PCN#20181205001.0

**Pin One Dot Symbolization change – Adding Pin One Dot for Select SC70, SOT-23,
and SOT-223 Devices
Information Only**

PCN Number:	20181205001	PCN Date:	Jan. 7, 2019
Title:	Pin One Dot Symbolization change – Adding Pin One Dot for Select SC70, SOT-23, and SOT-223 Devices		
Customer Contact:	PCN Manager	Dept:	Quality Services
Change Type:			
<input type="checkbox"/>	Assembly Site	<input type="checkbox"/>	Assembly Process
<input type="checkbox"/>	Design	<input type="checkbox"/>	Datasheet
<input type="checkbox"/>	Test Site	<input checked="" type="checkbox"/>	Packing/Shipping/Labeling
<input type="checkbox"/>	Wafer Bump Site	<input type="checkbox"/>	Wafer Bump Material
<input type="checkbox"/>	Wafer Fab Site	<input type="checkbox"/>	Wafer Fab Materials
<input type="checkbox"/>		<input type="checkbox"/>	Part number change
<input type="checkbox"/>		<input type="checkbox"/>	Assembly Materials
<input type="checkbox"/>		<input type="checkbox"/>	Mechanical Specification
<input type="checkbox"/>		<input type="checkbox"/>	Test Process

Current Symbolization (No Pin One Dot)	New Symbolization (With Pin One Dot)
SC70 Example		
SOT-23 3 Lead example		
SOT-23 5 Lead example

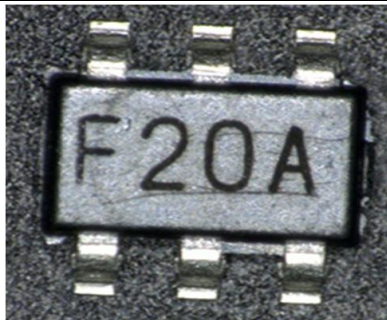
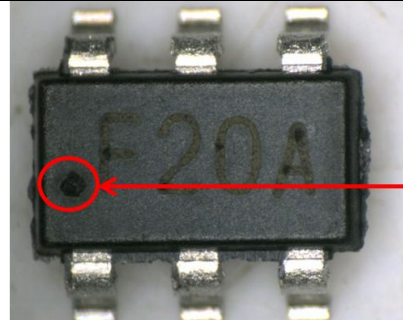
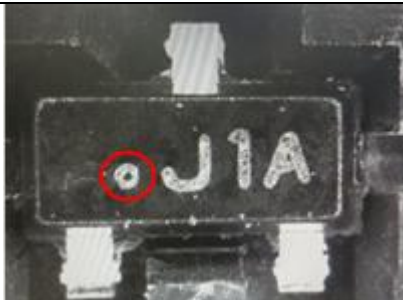
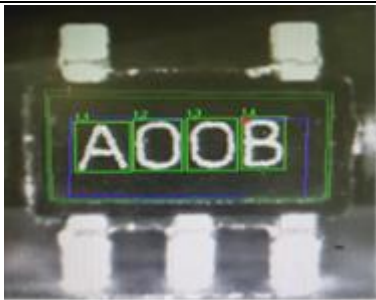
This letter is to inform of the addition of a Pin One dot in the devices symbolization of select SC70, SOT-23, and SOT-223 Devices:
